TRAFFIC CIRCULATION LAYOUT

RANCHO DEL CIELO APARTMENTS

REVISION
2-4-14
FILE SET
FEB 20 2014

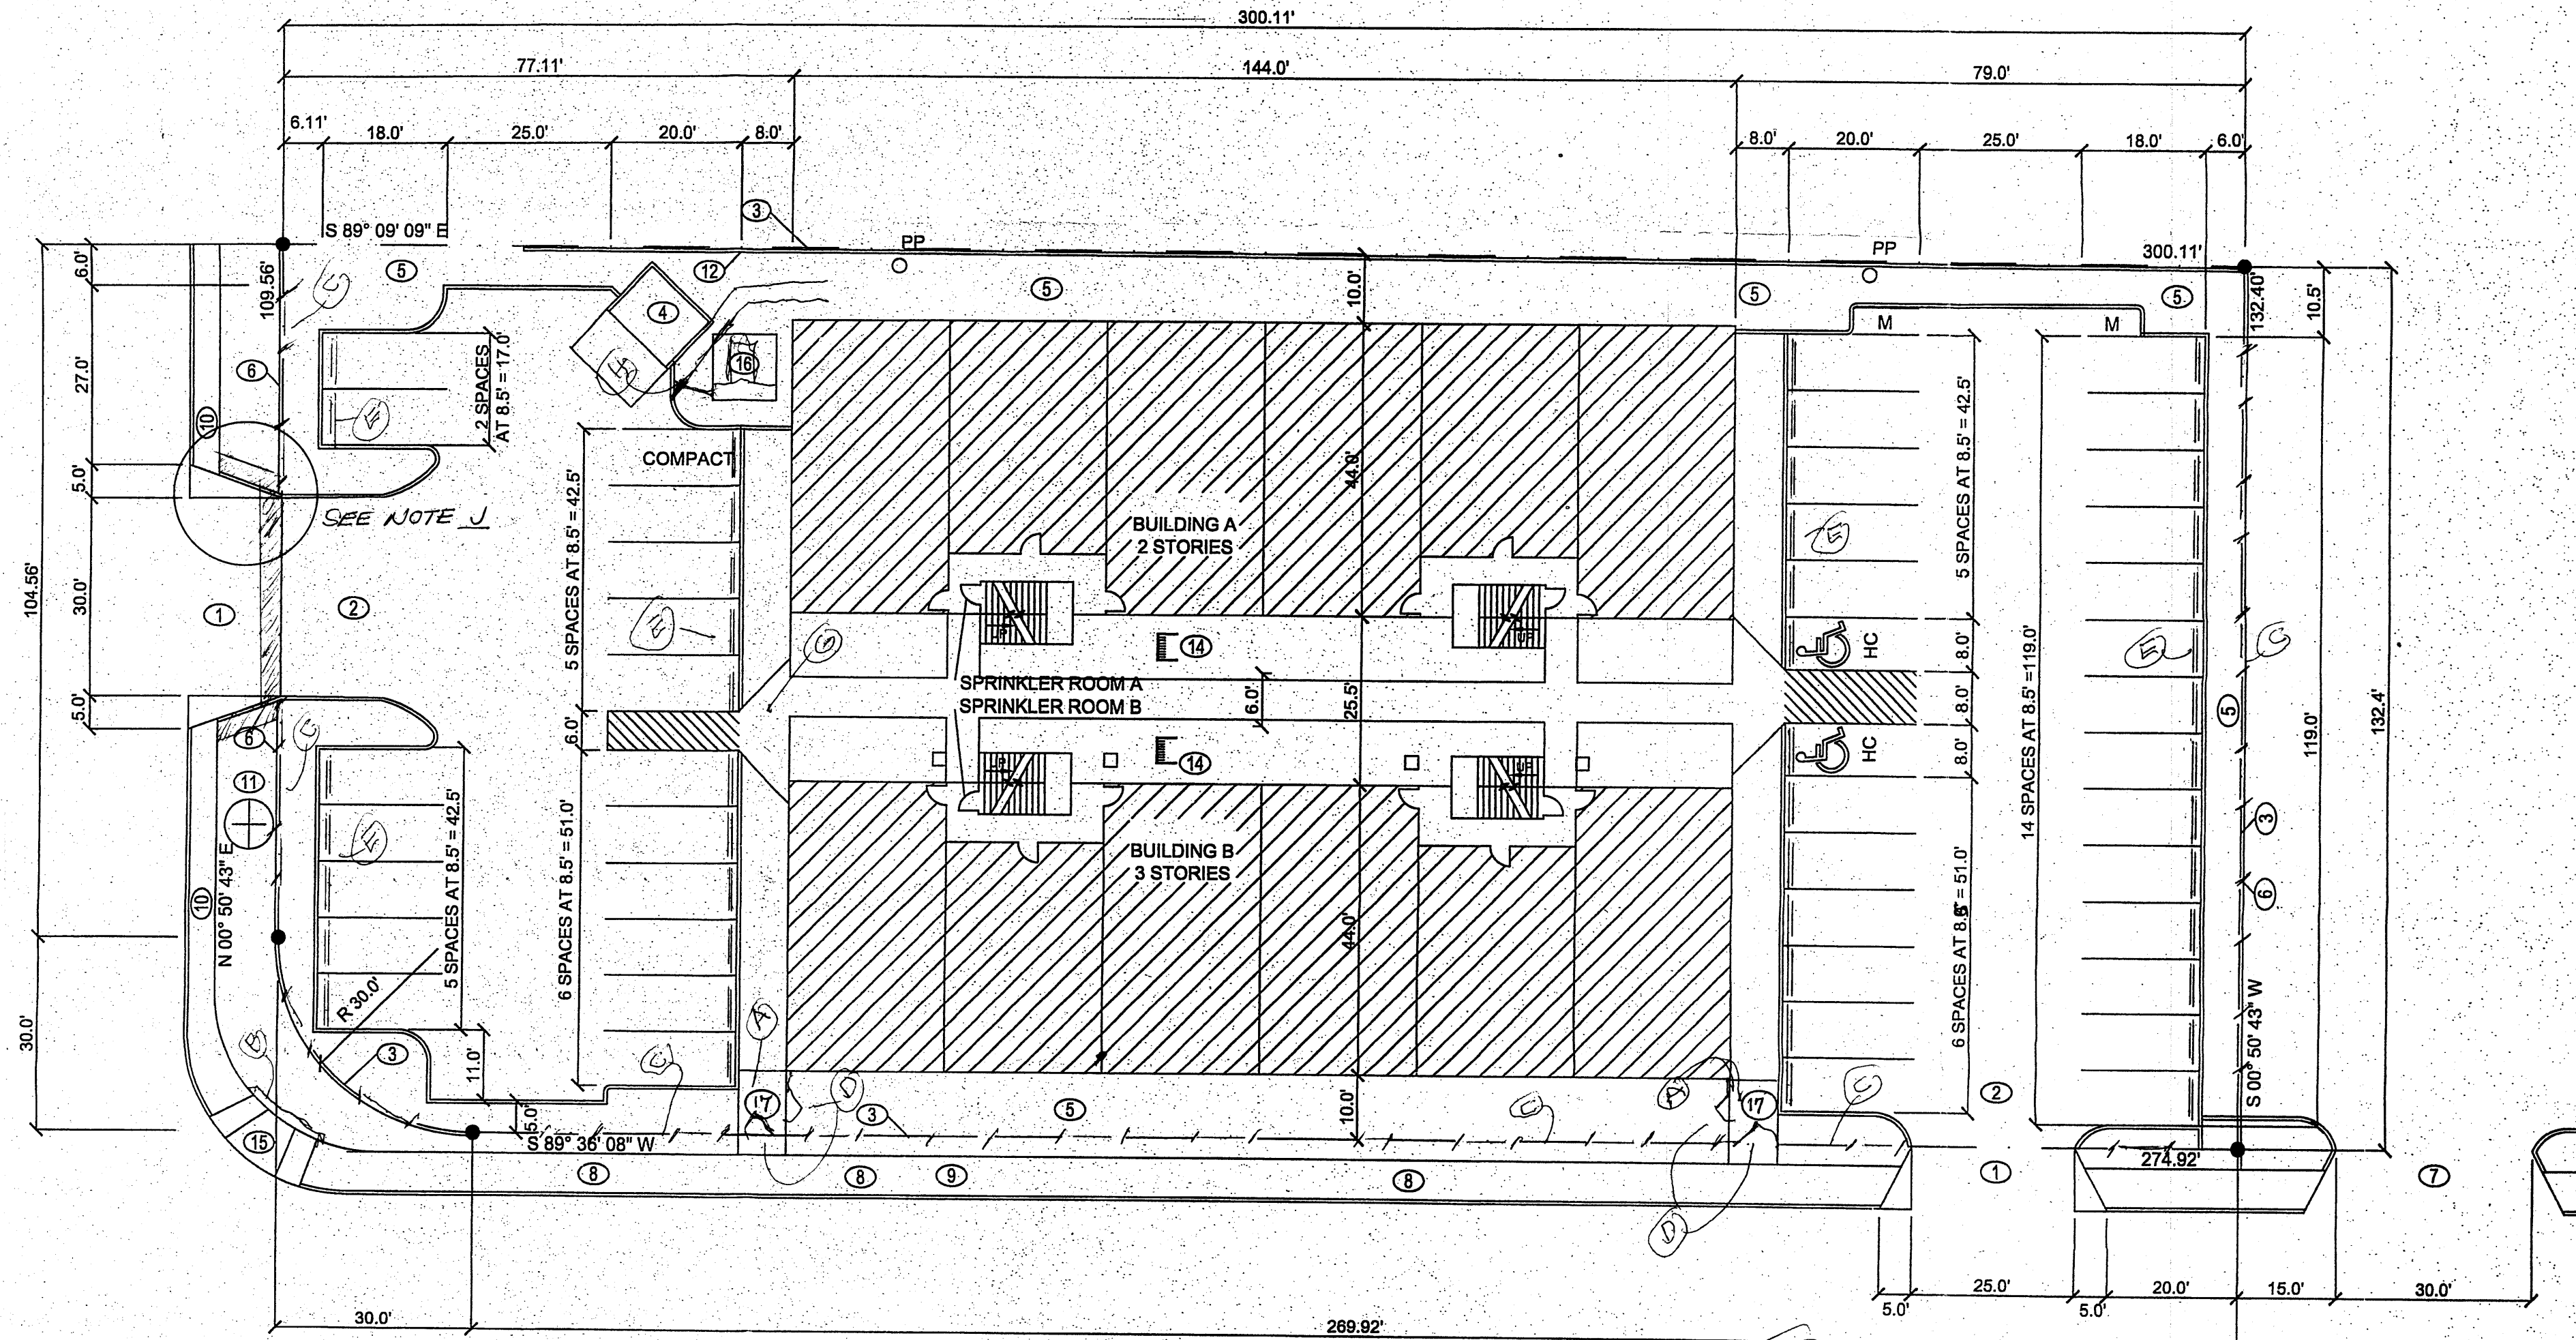
REVISE ADA WALK
D NEW 6" HIGH CURB PER CABQ 2441
C WALK FENCE
D GATE
E CONE BUMPERS
F 6" CONE WALK
G RAMP (LIMITED
NOT REQUIRED)
H REVISION 2
TAN'S TRAMP
SCALE: 1" = 20'

CONCRETE GRINDED DOWN TO
ELIMINATE LEDGE CAUSING A
TRIPPING HAZARD PER DISCUSSION
WITH MONICA ORTIZ AND SHAHAB BAZAR ON 2/14/14
PLEASE SEE ATTACHED PHOTOS

TRAFFIC CIRCULATION LAYOUT

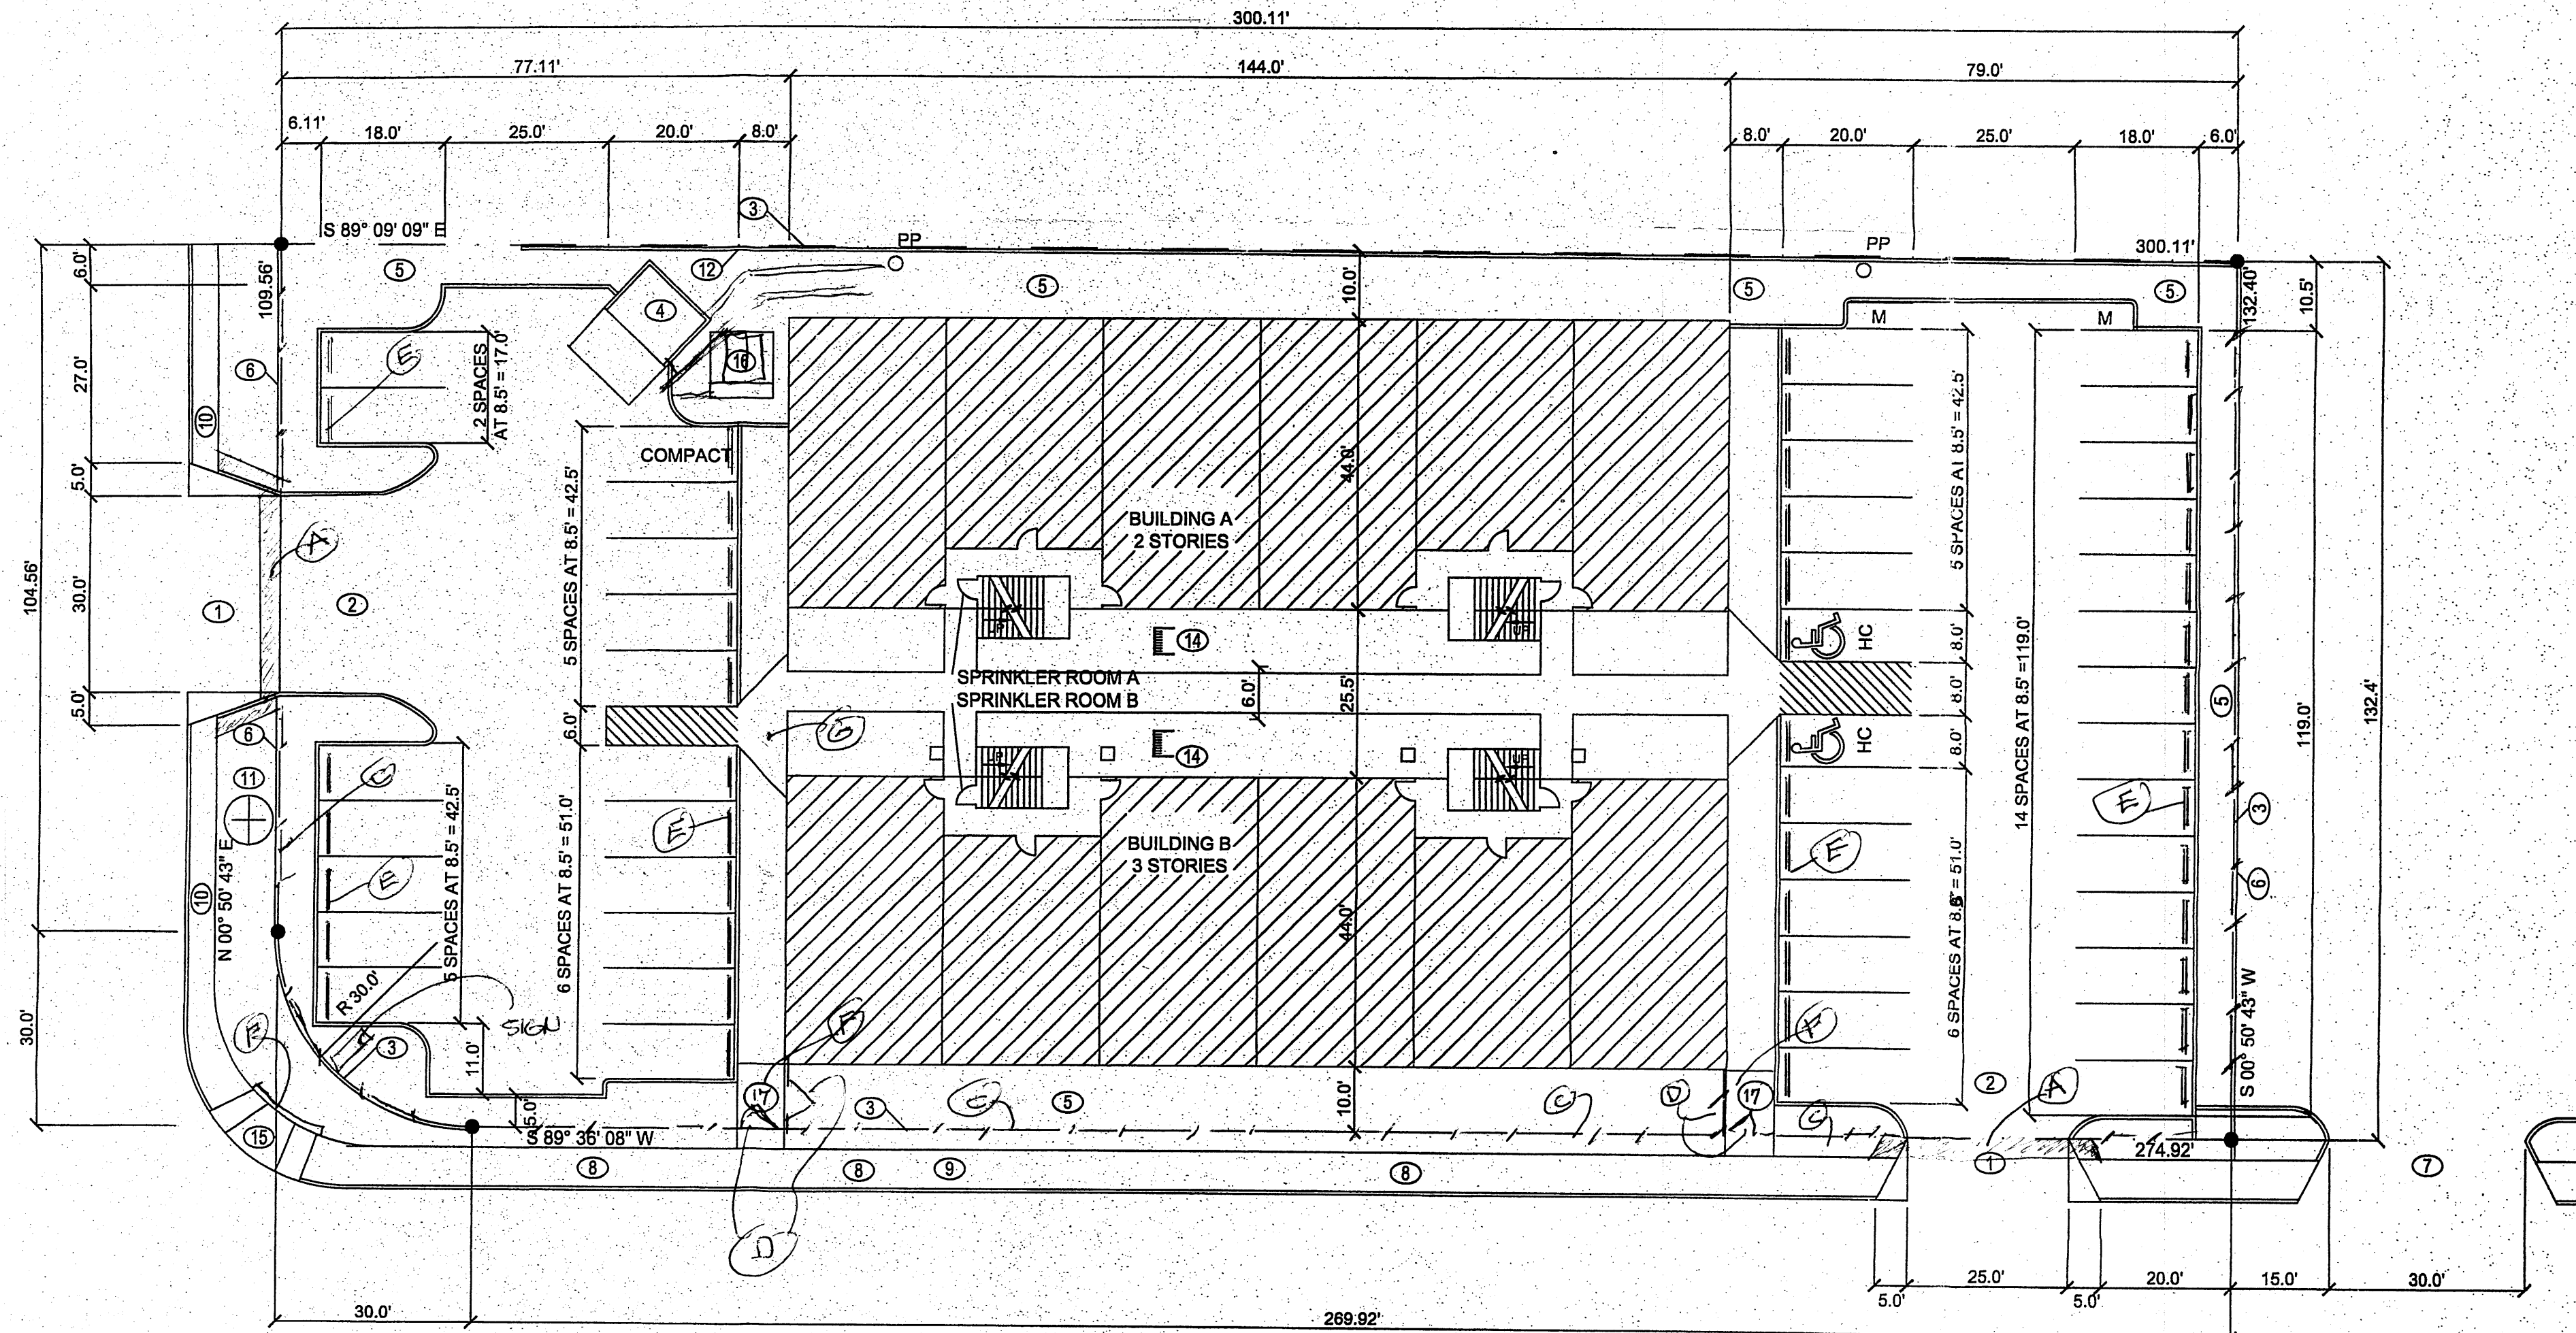
SEE PHOTOS
A REVISED ADA WALK
B NEW 6" HIGH CURB PER
C W.I. FENCE
D GATE
E CONC. BUMPERS
F 6" CONC. WALK
G RAMP (NOT REQUIRED)
H REVISED SCALE: 1" = 20'
TRANSFORMER

TRAFFIC CIRCULATION LAYOUT

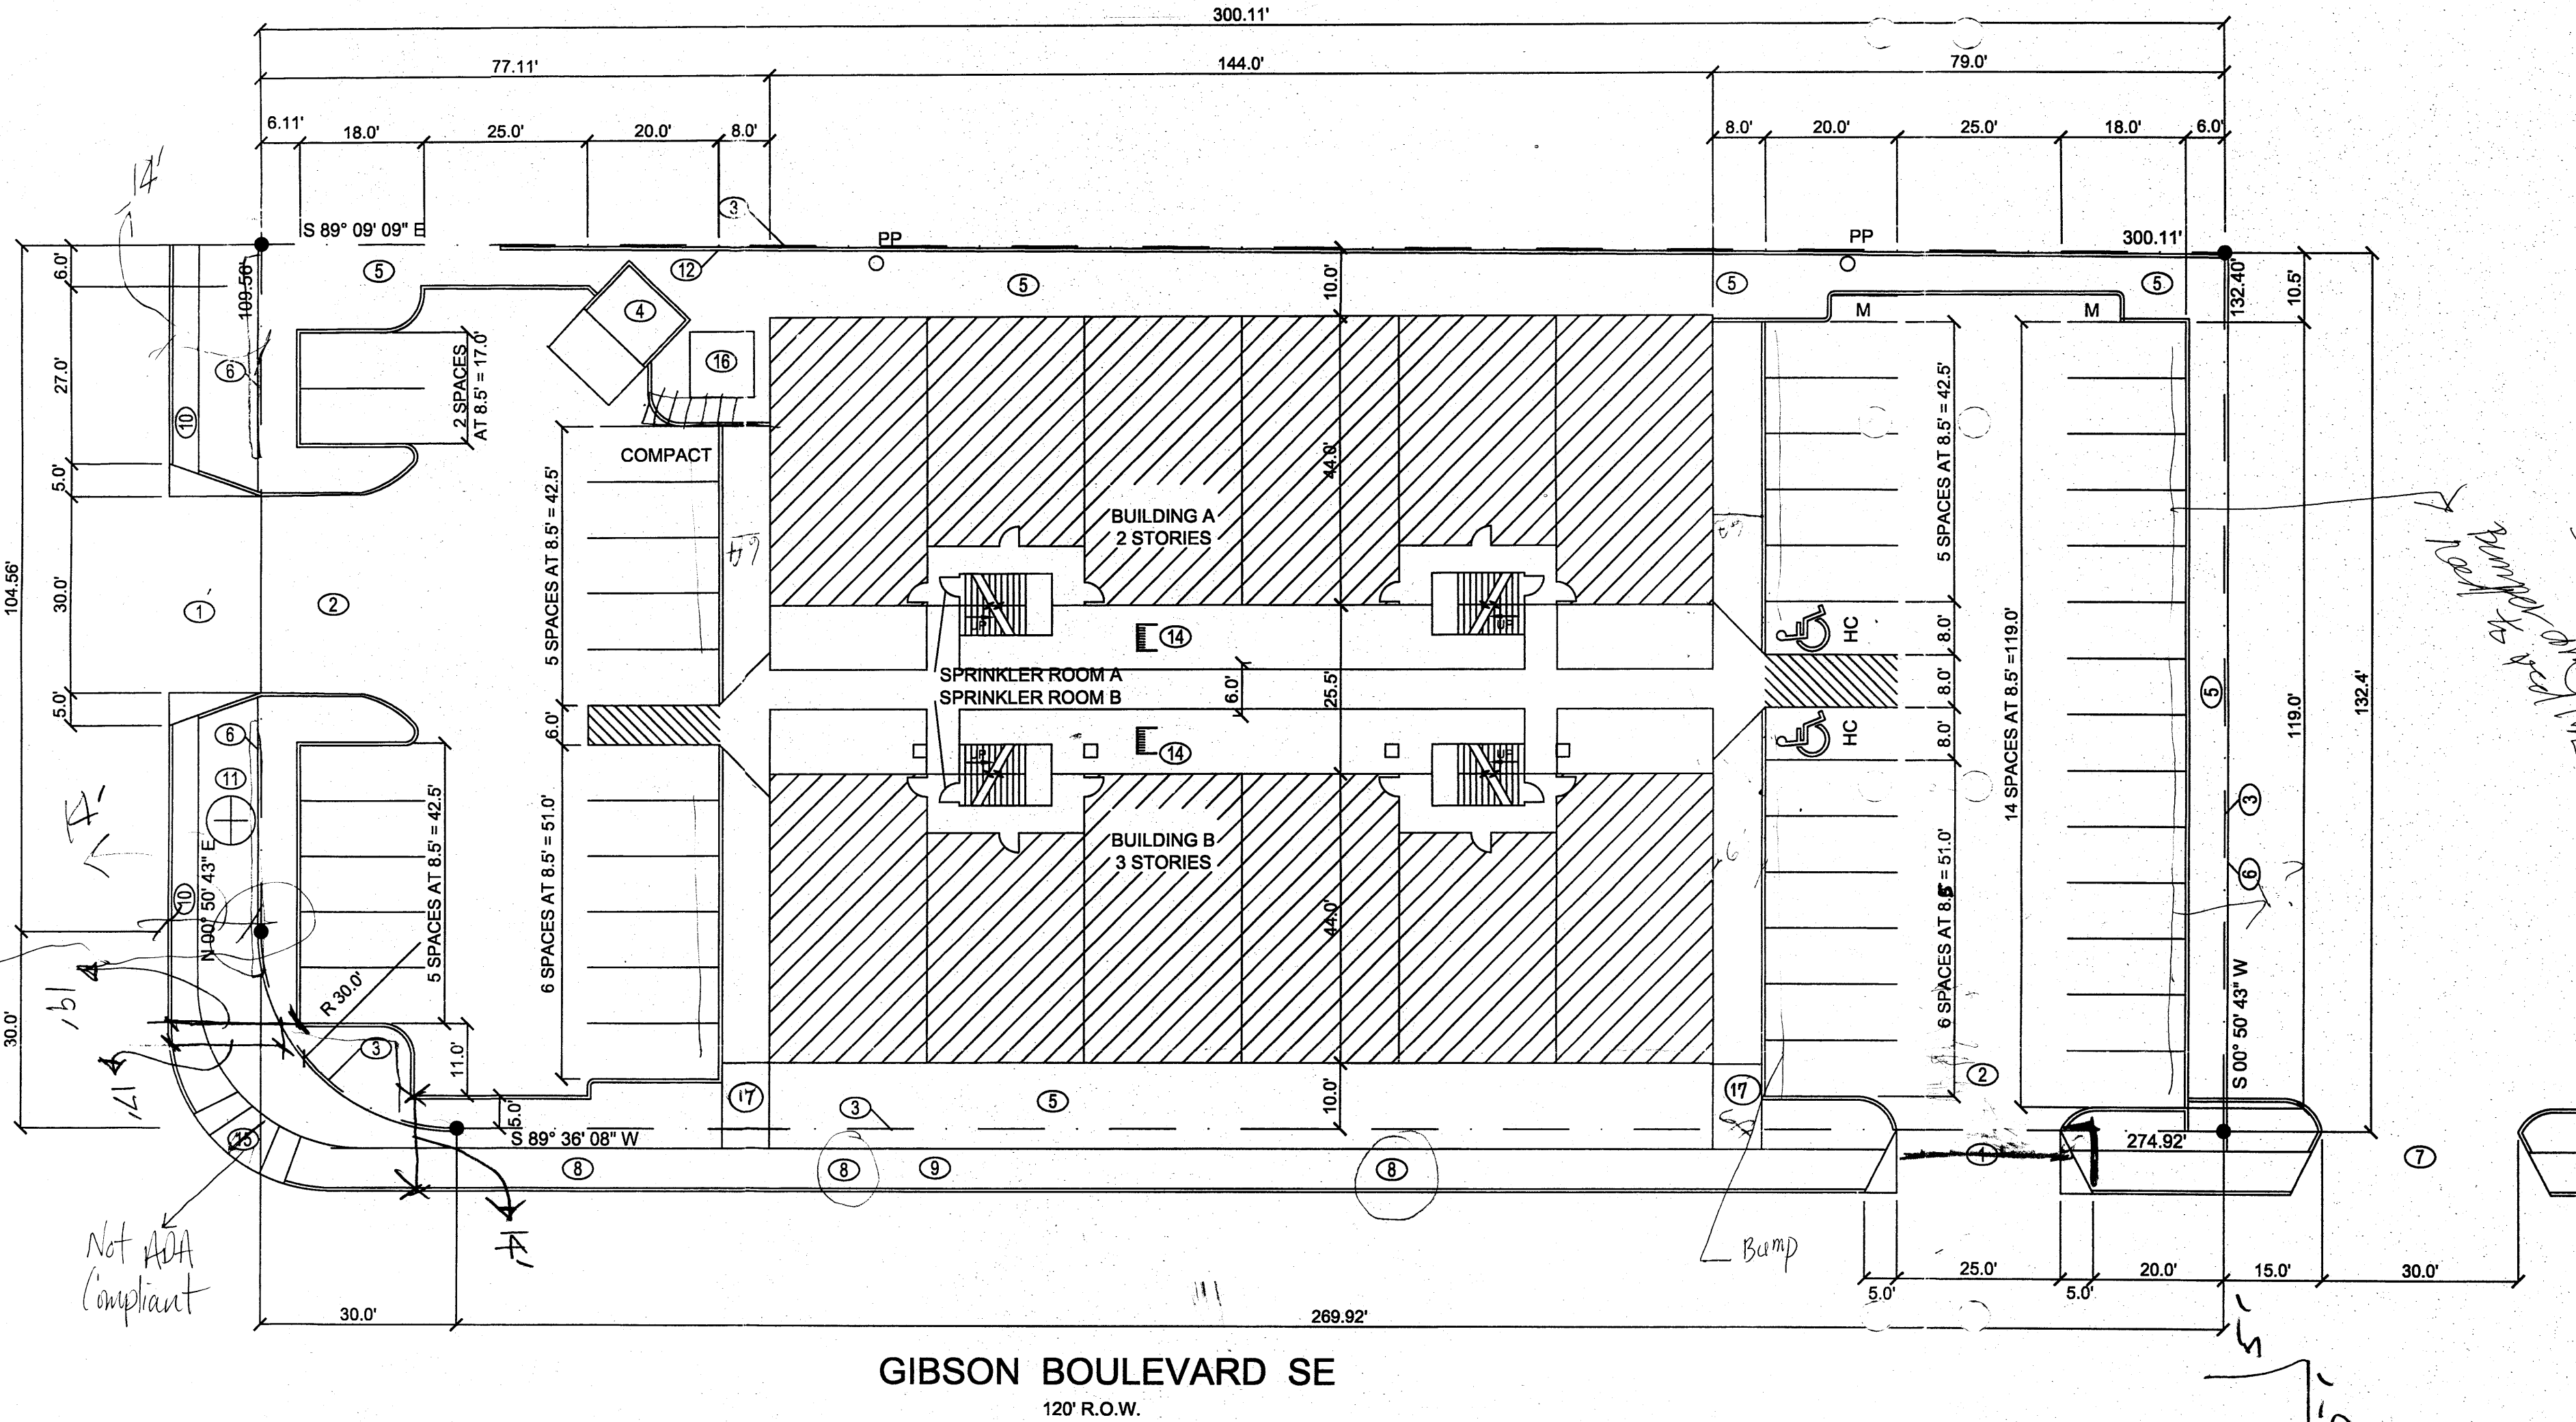
13'-2 1/2"
wall

Not ADA
Compliant

13'-0"
